## **BMAA Inspectorate Notice: CAA MPD 2017-001**

**Reference:** CAA MPD 2017-001

**Title:** Engine Cylinder Head – Inspection/Replacement/Reidentification

**Reference:** BMAA Service Bulletin 2612 issue 1  
**Title:** Rotax 912-series cylinder head temperature measurement  
**Applicability:** All BMAA aircraft with Rotax 912-series engine  
**Author:** Ben Syson, BMAA  
**Effective date:** 1 August 2016  
**Classification:** Recommended Service Bulletin

The drawings below show the old type head, which measures CHT, and the new type head, which measures coolant temperature. The new type head can be retrofitted to older engines (but is not suitable for use with waterless coolant, such as Evans’).

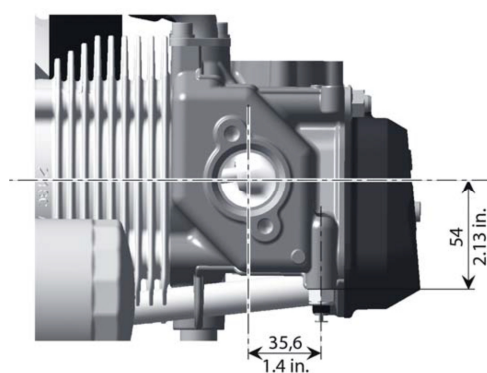
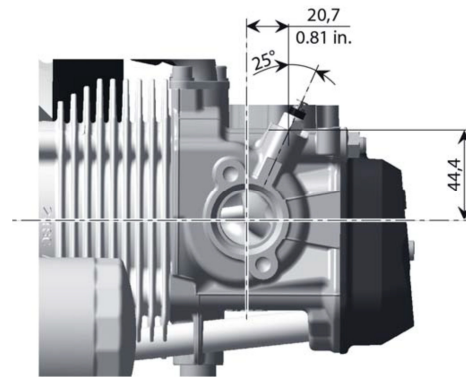
In 2013 Rotax changed the detailed design of the cylinder head on their 912-series engines (including the 912 / 912UL and 912S / 912ULS). The temperature measurement point, which used to measure cylinder-head temperature (CHT), now measures coolant temperature, which has a lower maximum temperature.

Rotax has decided that if an engine has a new type head fitted to it, the engine type designator should have ‘-01’ appended to. This is to help identify these engines in future documents. The photo to the right shows an amended type plate for a certified 912S engine.

**If your aircraft has a CHT gauge** (or displays CHT on an EFIS or EMS)...

- Check the cylinder head whose temperature it is measuring. If it is the new type of cylinder head:
  - Change the marking of the gauge to show that it is measuring COOLANT temperature, not CHT;
  - Change the maximum temperature limit on the gauge to the maximum coolant temperature of 120°C;
  - Ensure any engine limitation placard displays the maximum coolant temperature.

**If your engine has the new type of cylinder head...**

Append ‘-01’ to the engine type in the front of the engine logbook (if it does not have it already). For example a ‘912UL2’ becomes a ‘912UL2-01’. Also amend the type plate fitted to the engine (similarly to the photo above), although this can be delayed until the next time the engine is removed.
